# UNITED STATES PATENT AND TRADEMARK OFFICE

APPLICATION NO.	FILING DATE	FIRST NAMED INVENTOR	ATTORNEY DOCKET NO.	CONFIRMATION NO.
10/784,193	02/24/2004	Yoshiaki Okui	118827	1085

## Office Action Summary

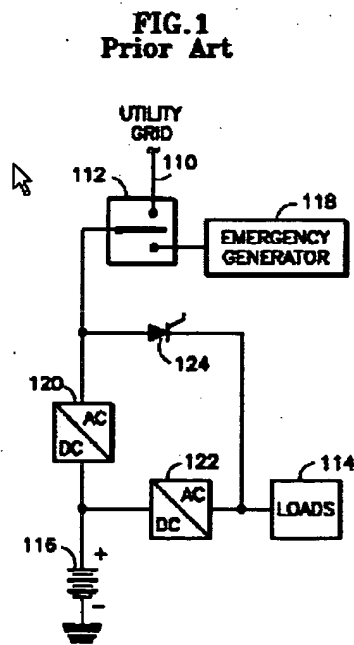
Young discloses in fig.1 an "on-line, double conversion" type UPS.

JP discloses in figures 1-3 and abstract a control circuit CPU and a judgment circuit judges the degradation of the storage battery based on a charging time of the storage battery.

SOLUTION: Using a clock IC 3 backed up by a primary battery 5 and a first memory 2, a clock data at power-on stored in a first memory 2 is compared with a clock data stored lastly before power-on to determine the power-off elapse time of a device. The clock data at power-on is compared with a clock data stored at a prescribed cycle after power-on to determine the power-on elapse time of a device. Based on the power-off elapse time and power-on elapse time determined respectively, the discharging time and charging time of a secondary battery 9 are controlled. It is thus possible to reduce the performance degradation of the secondary battery 9 and estimate the service life of the secondary battery 9 in step with charging and discharging cycle.

PROBLEM TO BE SOLVED: To reduce the performance degradation of a secondary battery by controlling the discharging time and charging time of the secondary battery based on power-off elapse time and power-on elapse time.
